Product Name:	514 - Minitex Power	
	514-5U4F-MINITEK PWR3.0 HSG	
Product Manager:	Jithin George	
Subject:	Notification of Change with Immediate Effectivity	
Distribution:	Affected customers	
Type of Change:	Design Change	
Change Description:	Product improvement activity with addition of extended shroud on the Housing body to be aligned with the updated PCIe SIG specification for 12VHPWR Cable Plug Housings. Changes are described in attached PPT.	
Reason for Change:	In accordance to ECR of PCIe SIG specification	
Affected Parts:	10161719-124GLF	
Effective Date of Change:	October,31 2022	
Last Time Buy Date:		
Earliest Disty Return Date:		
Last Time Shipment Date		
Datasheet Attached?	No	
Qual/Test Data Attached?	No	
Samples Availability Date:	31 October ,2022	
Available Alternatives?		
Questions?	<i>Contact your local Amphenol Representative, or Product Manager</i>	
	<i>Jithin George / Product Manager</i>	
	<i>Jithin.George@fci.com</i>

ENGINEERING CHANGE NOTIFICATION

Product: 10161719-124GLF Minitek 3.0 PCIe CEM 5 Receptacle Housing

- Site CCB No./Global PCN No. -COK-48-22
- Implementation Date: 31st OCT 2022

BEFORE

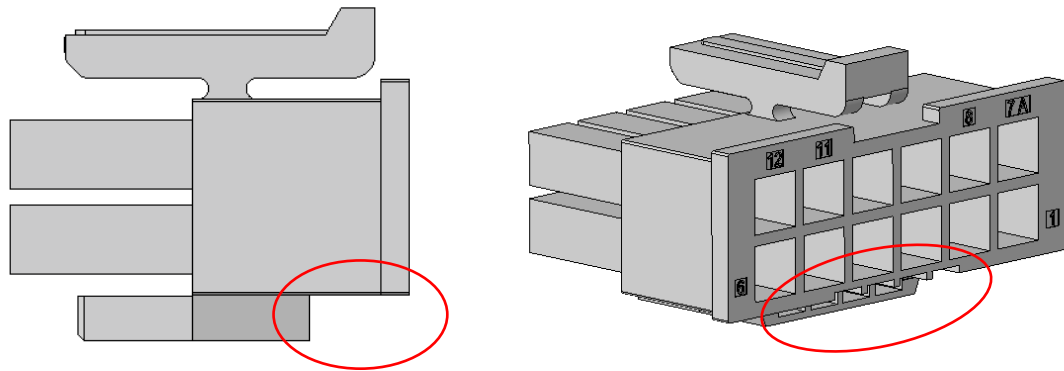
- ✓ Design → Design following PCI Express Card Electromechanical Specification Revision 5.0, Version 1.0

Option-1: 10161719-124GLF

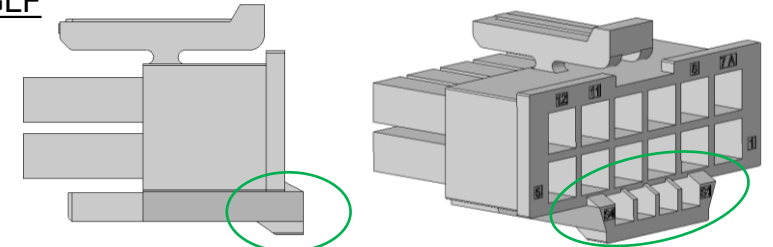
- ✓ Design → Design change as per ECR dt 3rd June'2022 of PCI Express Card Electromechanical Specification Revision 5.0, Version 1.0
- ✓ Current part will be modified according to Option 1 of specification by adding shroud extending beyond plug body and with gripping feature.
- ✓ Option 2 as defined in specification will be supported by a new Part number and having only a shroud extending beyond plug body
